Product Change Notification (PCN)

PCN #: 9E-2021

DATE: 27th September 2021

5.1 Module & Adapter Labels (on device)

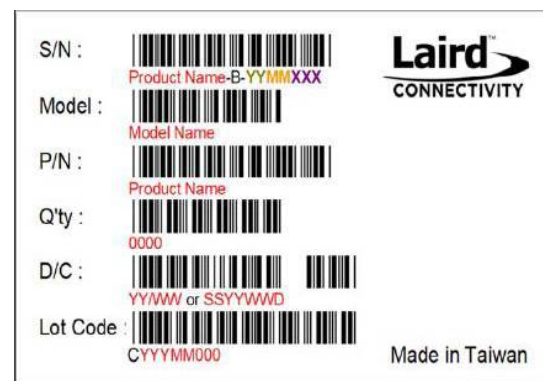
- Added UKCA certification logo to product labels for all of RM024 10mW modules

5.2 Shipping Bag and Box Label

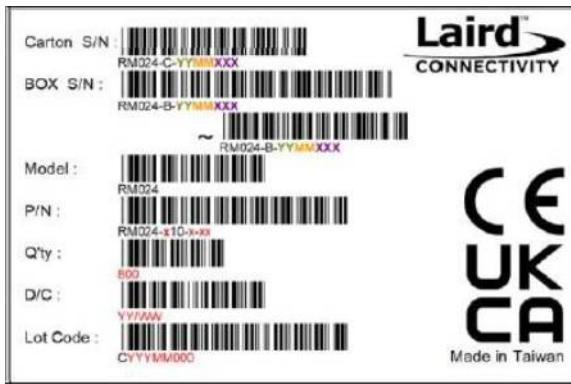
- Add Laird Connectivity logo, CE and UKCA logo to all RM024 10mW series shipping bag label
- Add Laird Connectivity logo to all of RM024 125mW series shipping bag label

5.3 Carton label

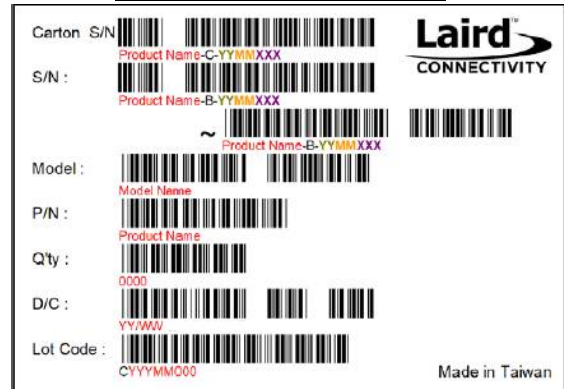
- Add Laird Connectivity logo, CE and UKCA logo to all RM024 10mW series shipping carton label
- Add Laird Connectivity logo to all of RM024 125mW series shipping carton label
